District staff's response to initial peer review report.

**Southwest Florida Water Management District
Response to the Initial Peer Review of
Proposed Minimum Flows for the
Lower Peace River and Lower Shell Creek**

June 1, 2020

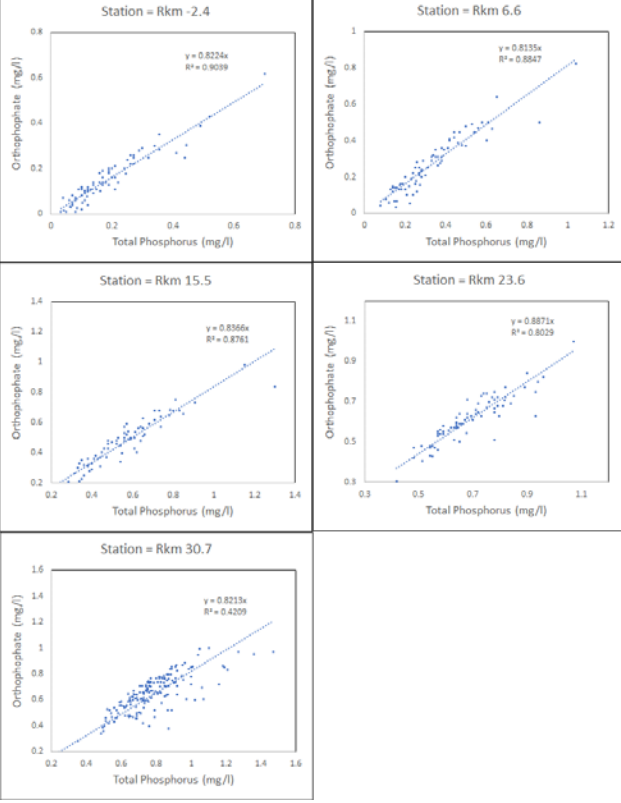
As important as the hydrologic and hydrodynamic models are, the Panel felt that they could have been described in greater detail earlier in the draft report. While the hydrodynamic model is viewed as a substantial improvement from the work included in the 2010 MFL report, the hydrologic model has limitations related to those portions of the watershed located downstream of gages. Also, and touched on later, the factors that account for the conclusion that a result of groundwater withdrawals is a reduction in baseflow in parts of the Peace River watershed, but an increase in baseflow in locations such as Joshua Creek – those factors should be discussed in greater detail. The assumptions and data limitations associated with quantifying the water budget from both ungauged and gauged sources should be more clearly discussed.

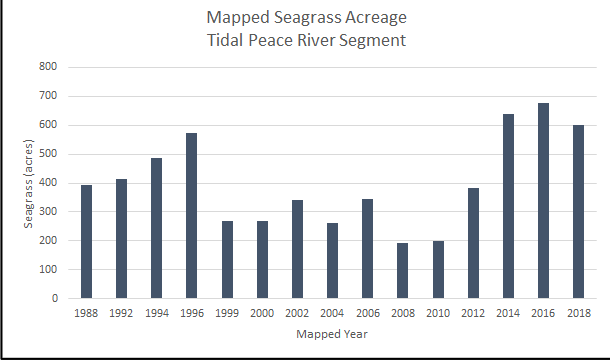
Hypoxia was mentioned numerous times in the report and during our discussions. It would be good to have a more comprehensive discussion in the report on the naturally-occurring as well as non-naturally-occurring hypoxia, how they impact the Charlotte Harbor system, how they are influenced by the high flow from Peace River (e.g., what rate of flow triggers hypoxia? 20000 cfs? 1000 cfs?), and how will they be affected by the MFL.

Please see response 1i in Table 1, response 2g in Table 2 and response 5p in Table 5.
